# ALERT SERVICE BULLETIN

NO. 205B-10-55

**MODEL AFFECTED:** 205B

**SUBJECT:** Inspection of Transmission Oil Line P/N 70-061L000V360A for Correct Length.

FIGURE 1

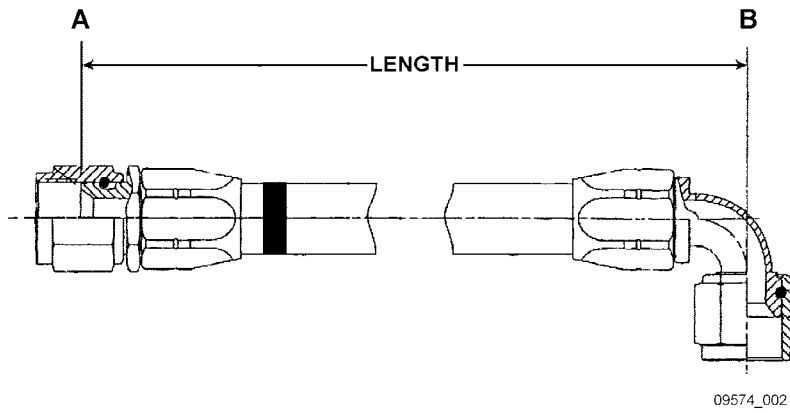
6. Lay the Hose Assembly on a flat surface and measure the length of the Hose as detailed in Figure 1.
7. If the part number 70-061L000V360A Hose Assembly is 36.5 inches (92.71 cm) to 37.5 inches (95.25 cm) then the Hose Assembly must be re-identified, as detailed in step 8.

8. Using a vibrating stylus, vibro-etch a single line through the last four characters of the part number 70-061L000V360A on the tag. Then re-identify the part number of the Hose Assembly as 70-061L000V370AFM.

9. If the Hose Assembly part number 70-061L000V360A measures less than 36.5 inches (92.71 cm) it must be replaced by new part number 70-061L000V370A Hose Assembly prior to further flight.
10. Hoses measuring more than 37.5 inches (95.25 cm) must be replaced by new part number 70-061L000V370A Hose Assembly prior to further flight.
11. Re-install the Hose Assembly and ensure there is no fowling between the Hose Assembly and any airframe components, drive system components, and wiring on the aircraft. See Figure 2 and view "A" for the correct routing of the Hose Assembly.
